UNITED STATES PATENT AND TRADEMARK OFFICE

APPLICATION NO.	FILING DATE	FIRST NAMED INVENTOR	ATTORNEY DOCKET NO.	CONFIRMATION NO.
10/072,707	02/05/2002	Alain Houle	CISCP730	1909
54406	7590	07/10/2006	EXAMINER	
AKA CHAN LLP / CISCO 900 LAFAYETTE STREET SUITE 710 SANTA CLARA, CA 95050			KIM, DAVID S	
			ART UNIT	PAPER NUMBER
			2613

Office Action Summary

DETAILED ACTION

Fig. 4A

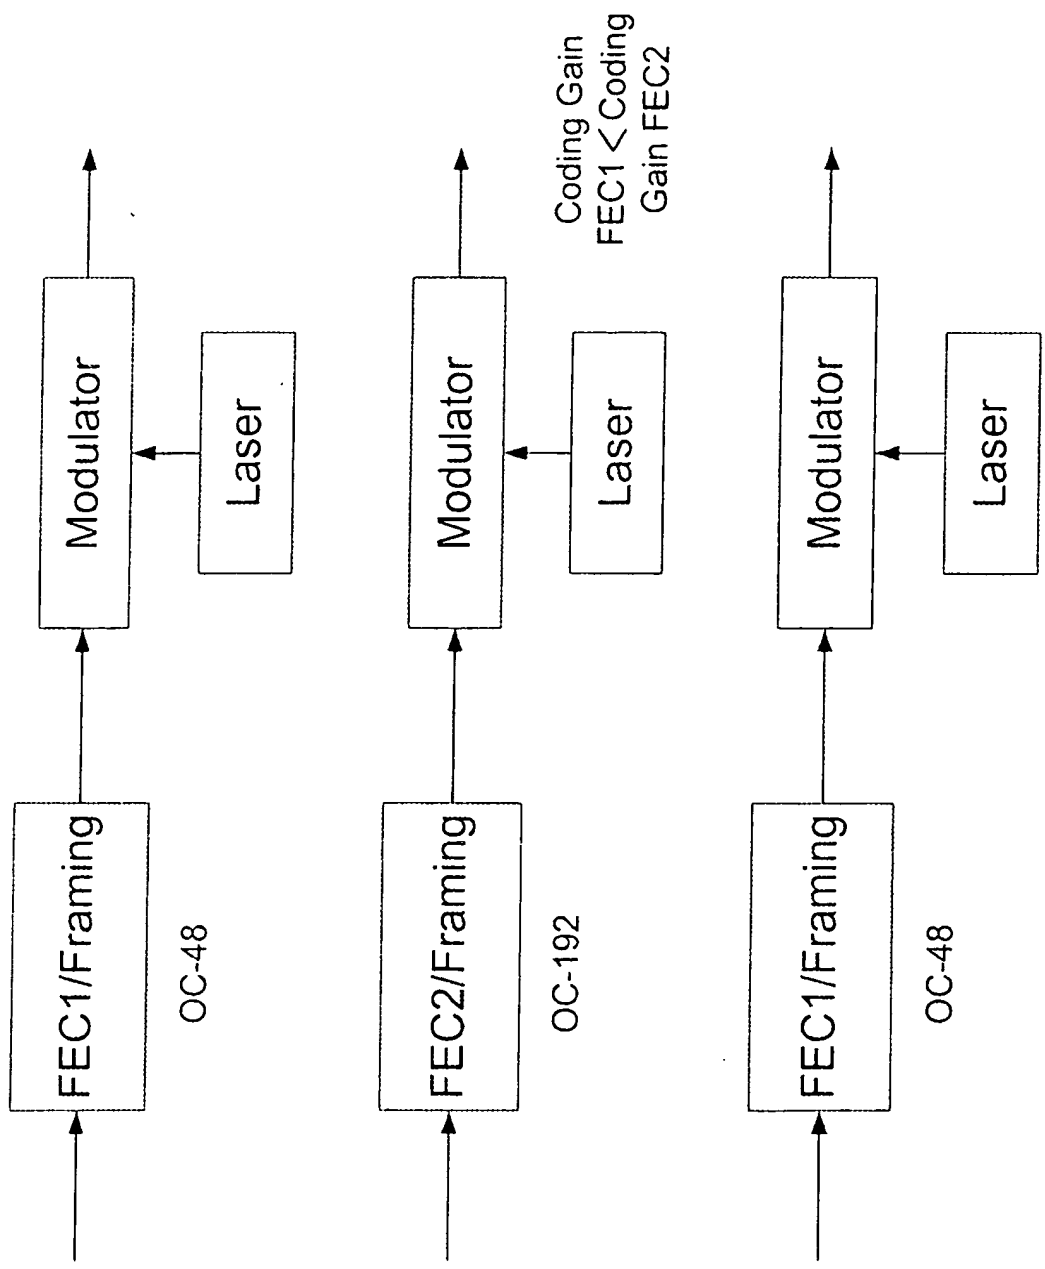
1. Applicant's compliance with the objections to the drawings in the previous Office Action (mailed on 28 April 2006) is noted and appreciated. Applicant presents arguments to assert that Fig. 4A is supported in the Applicant's specification, citing portions from p. 8-9 of the specification (arguments filed on 28 April 2006, p. 10+). In particular, citation of the following portion is persuasive:

"Alternatively, error correction coding techniques may also be employed on both the higher data rate and lower data rate signals with different coding gain" (Applicant's specification, p. 9, l. 20-22).

In the context of the specification, "the higher data rate signal" corresponds to an OC-192 signal, and "the lower data rate signal" corresponds to an OC-48 signal. Accordingly, the drawing replacement sheet of Fig. 4A, filed on 24 March 2005, is approved.
